ADDENDUM 6
Via E-Mail
DATE: May 16, 2024

Contract: 23-C-00013; Morris Bridge Filter Building Improvements ReBid

| FILTER BUILDING TYPICAL FILTER SECTIONS | | | |

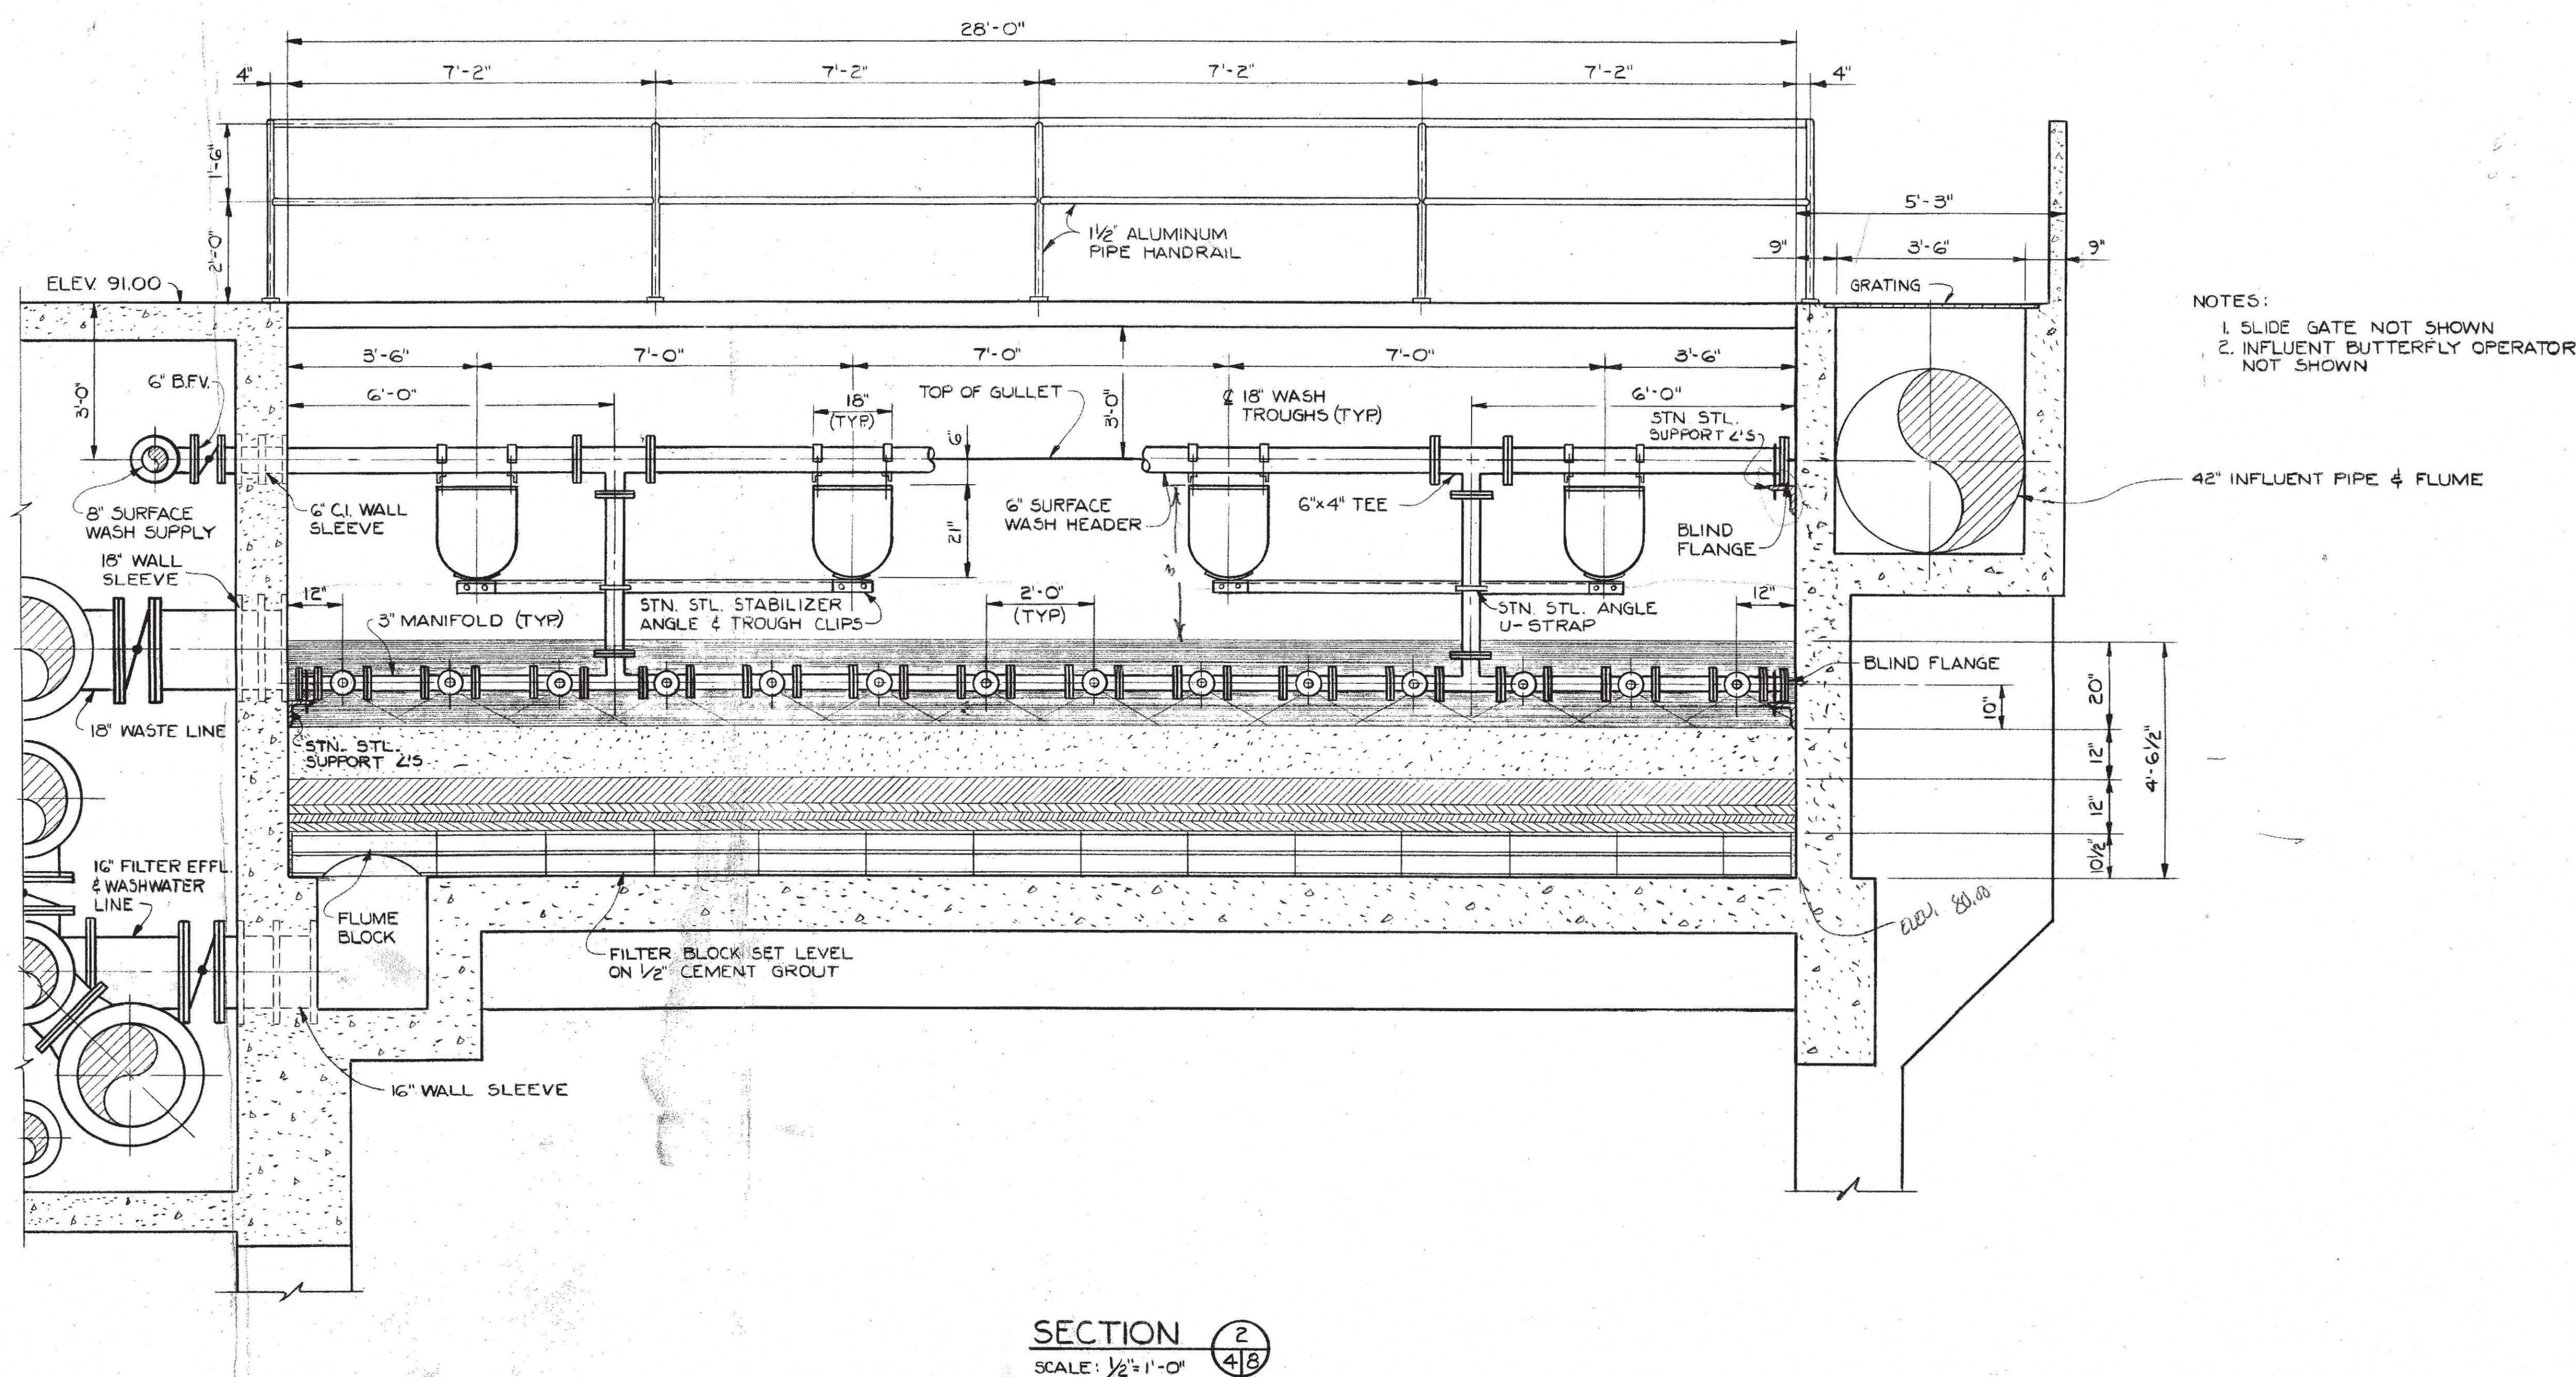
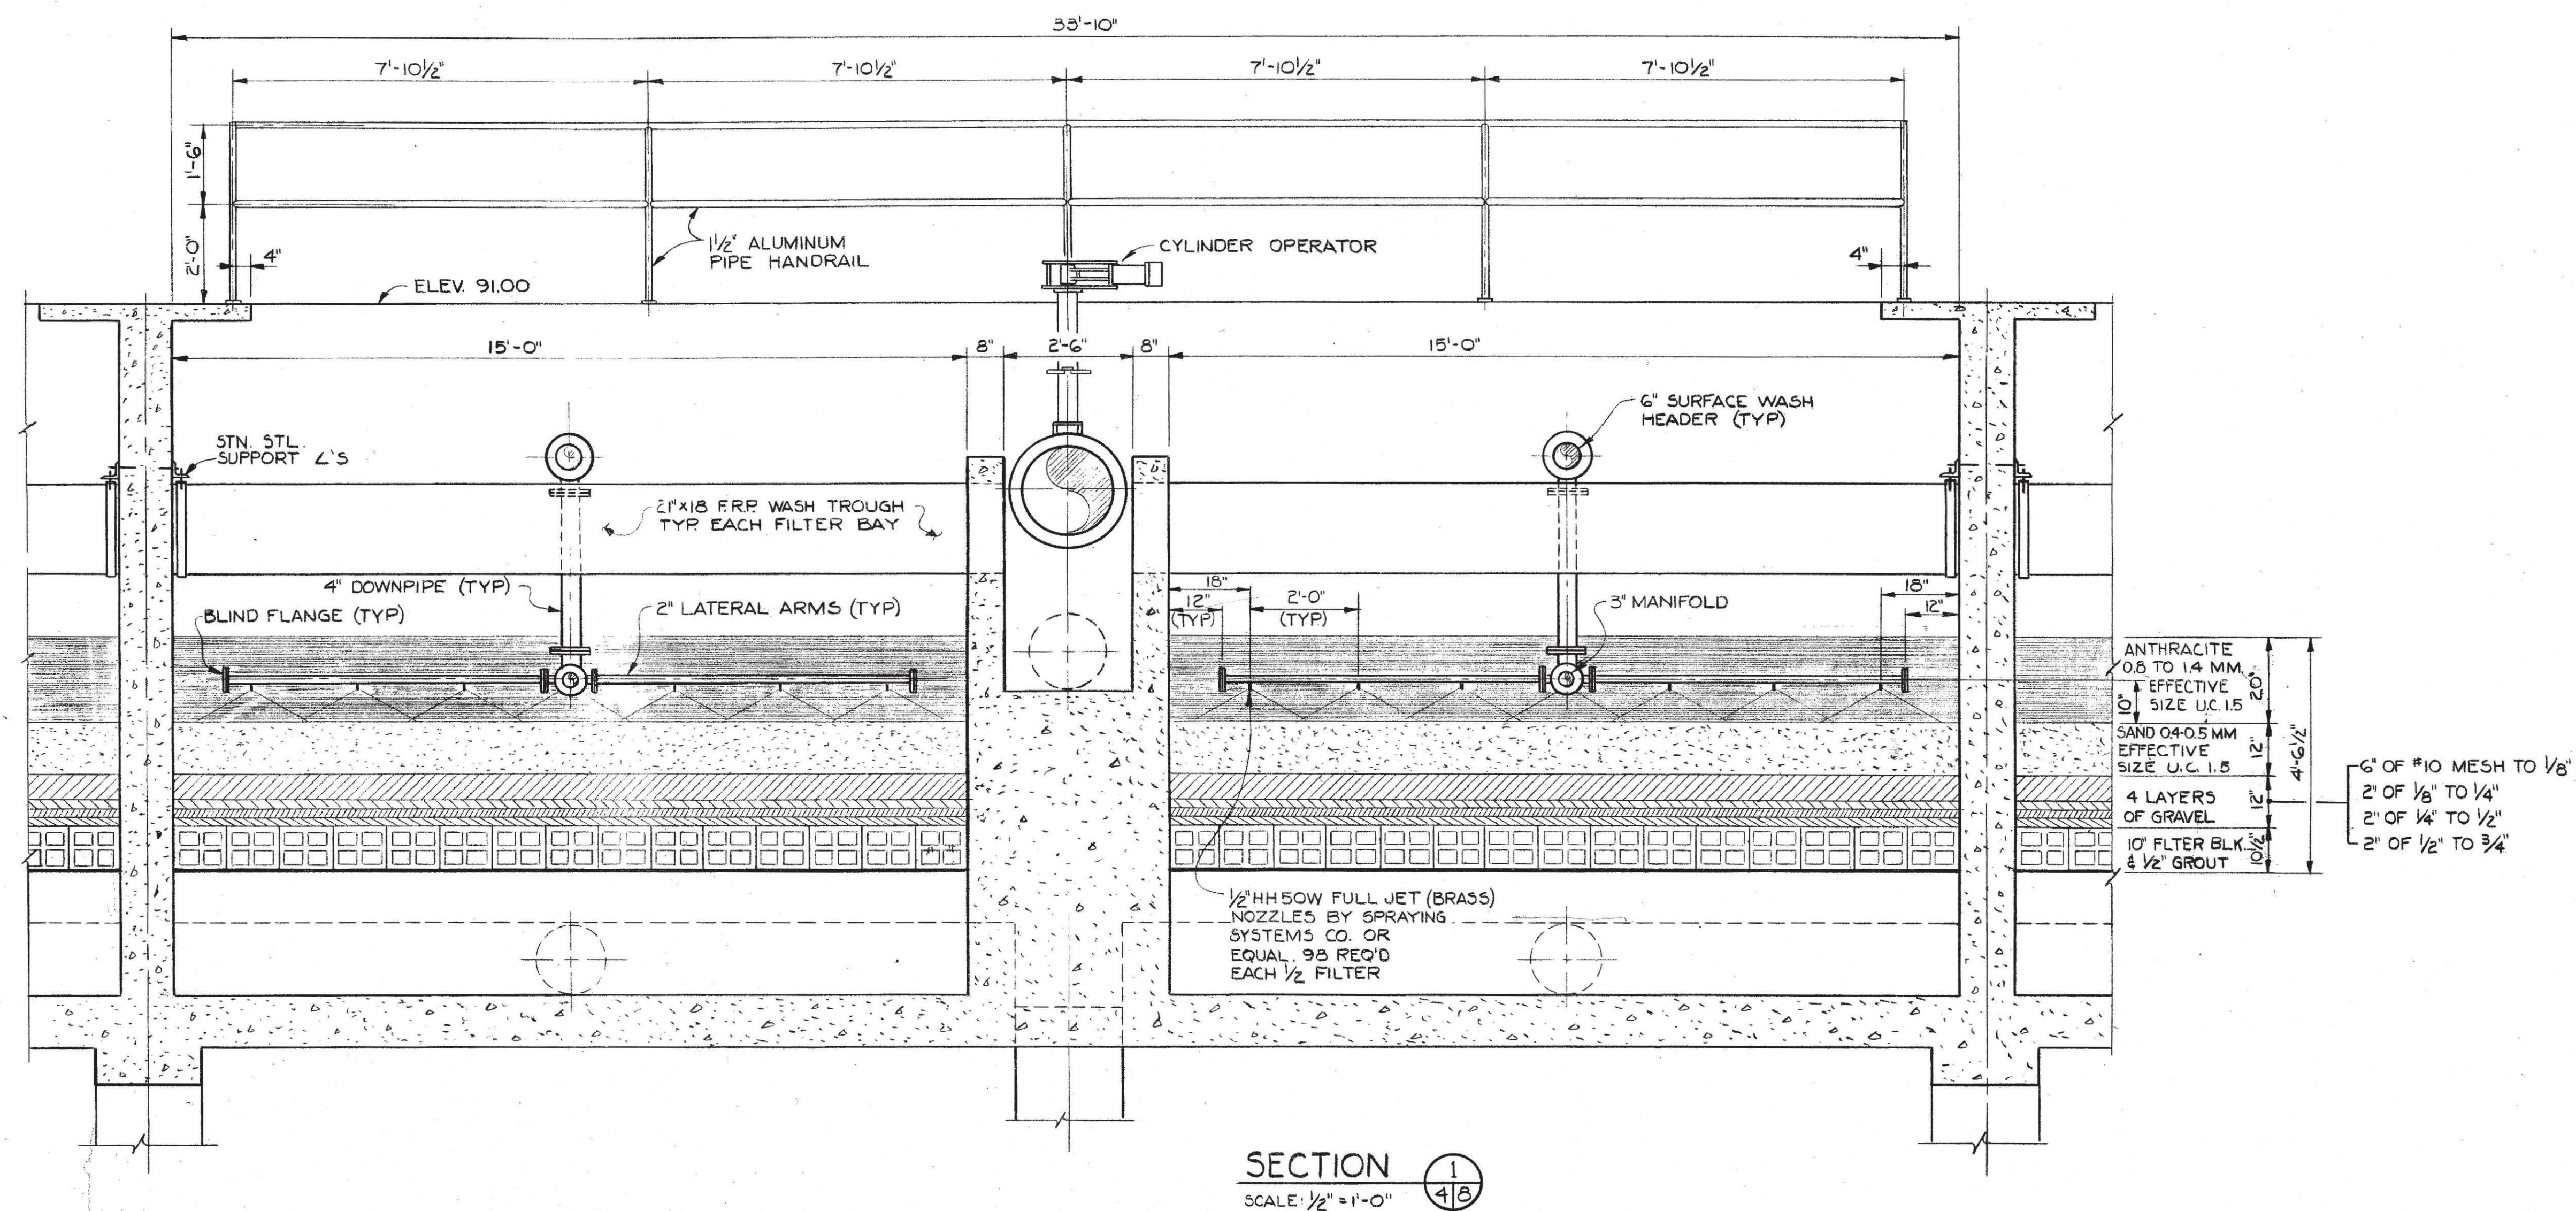
3. In addendum #4 question #1 asked for cross section of filter tank? Answer - c. contractors to use mean and methods to demo work of tanks sub floors. We still don't have detail of how the clay tile/brick are installed and supported structure. Can't estimate without know how it was built. Or does this abbreviation PV in pricing sheet 18 deal with as a allowance?
See attached as-built.

4. How many drains are per filter tanks and is there any way for a color pipe chart layout for these?
See attached as-built. Color pipe chart layout not available.
